CITY OF ST. HELENS PLANNING DEPARTMENT

MEMORANDUM

TO: Planning Commission acting as the Historic Landmarks Commission
FROM: Jennifer Dimsho, AICP, Associate Planner
RE: 71 Cowlitz Street (The Klondike Tavern) Architectural Review
DATE: March 5, 2024

01 PROPOSED SITE PLAN
 SCALE: 1"=10'

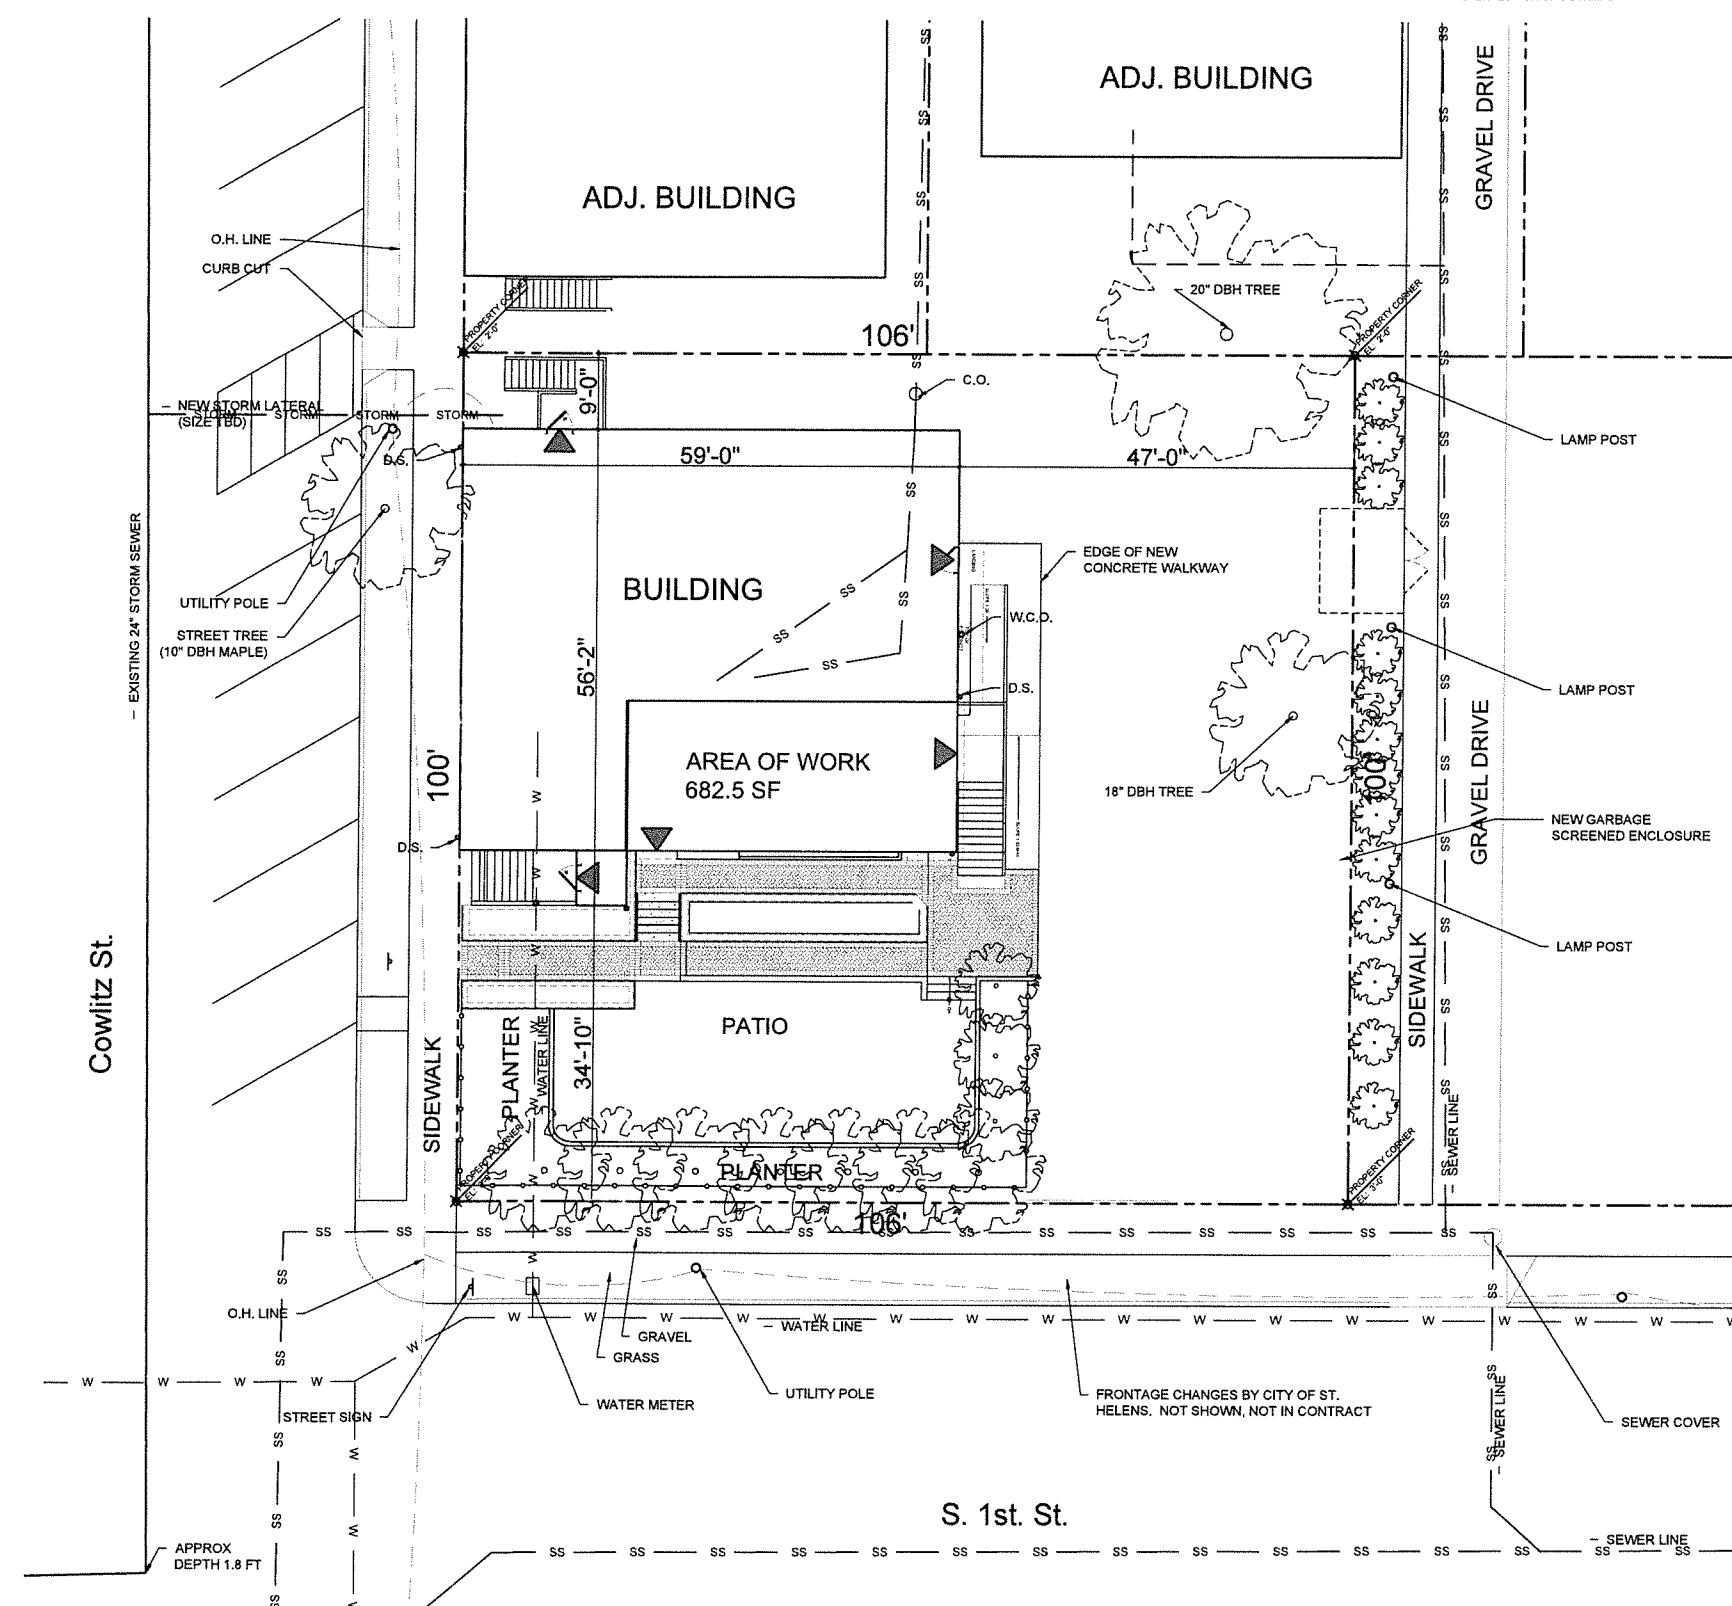
The Guidelines encourage projects to keep the building alignment at the front property line oriented towards the street. Adding an elevator on the west elevation will mean that guests who arrive for the 2nd and 3rd floors will likely enter not from the existing stair entry closest to the street, but they will enter at the entry which provides them closer access to the elevator. However, given the history of the west elevation and that the main entry stair was added in 1951 and will remain, staff does not feel there is an alternative solution which meets this requirement better than the proposal does.

01 PARTIAL SECOND FLOOR PLAN
SCALE: 1/4"=1'-0"

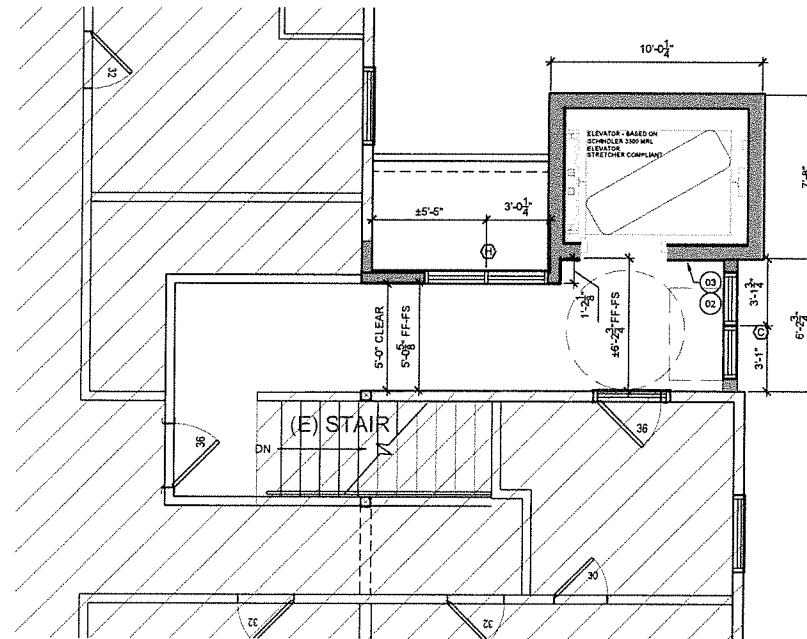
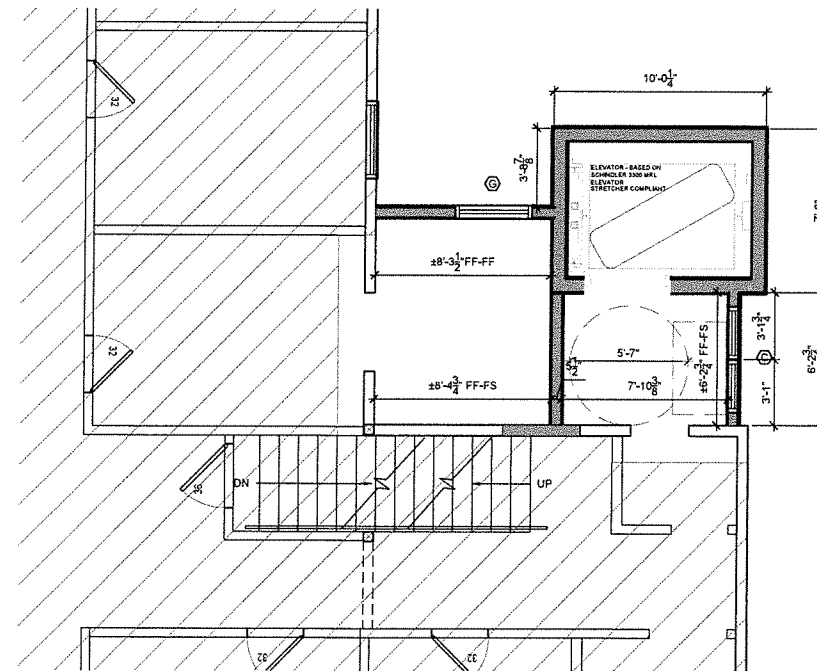
The Guidelines also discuss keeping original windows and not covering or obscuring historical windows, particularly on upper levels. It says where structural rehabilitation requires covering of windows, window cuts should be filled with complementing building materials. **Does the Commission feel that the modifications to the west and south elevations related to removal of the original windows, and the obscuring of original windows, is justified given the applicant's need for accessibility improvements to rehabilitate the 2nd and 3rd floors? Have alternative locations which do not require these modifications been ruled out?**

Some of the windows on the historic interior courtyard facade will be either replaced by doorways or removed in order to add the elevator tower and bridging. We are tucking the elevator and bridge into the interior corner away from the street and intersection to minimize the visual impact of these window changes.
